Erratum No. 3 to the NLGA Standard Grading Rules for Canadian Lumber (2022)
(effective November 29, 2023)

Note: This Erratum corrects *Interpretations of the National Grading Rule for Dimension Lumber*

FIGURE 4c

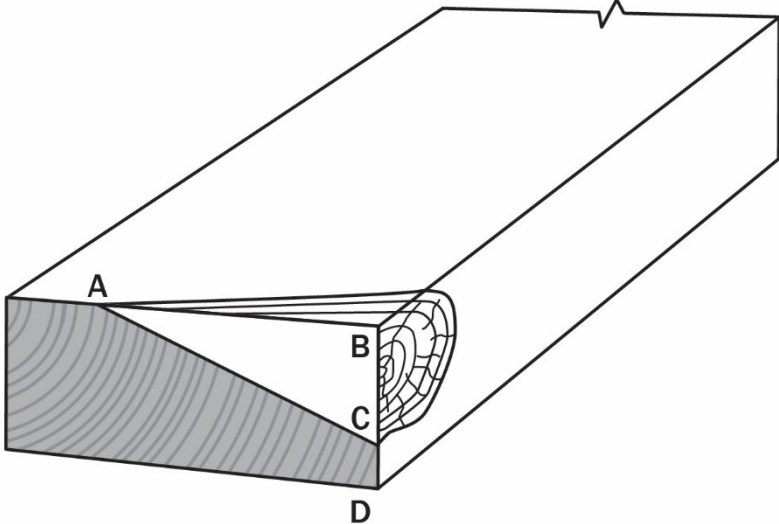
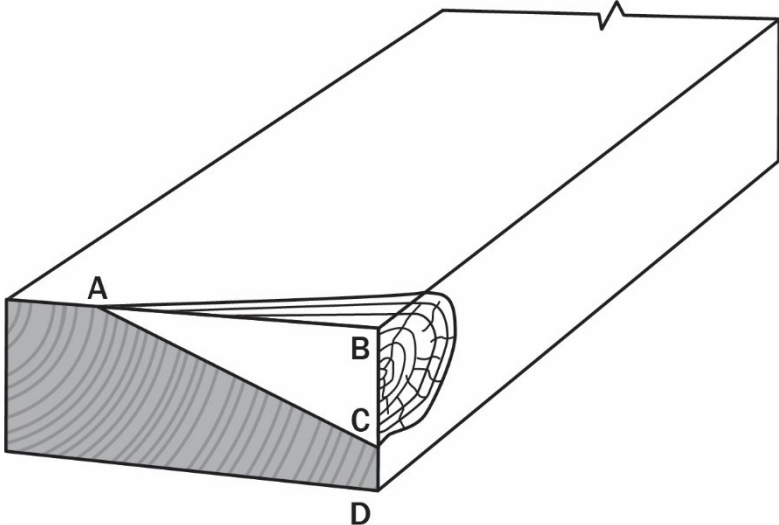
- Figure 4c: to correct the formula in the caption

$$\text{Knot size} = (\text{Length AB} \times \text{Length BC}) / 2 \times \text{Length BD}$$

$$\text{Knot size} = (\text{Length AB} \times \text{Length BC}) / (2 \times \text{Length BD})$$
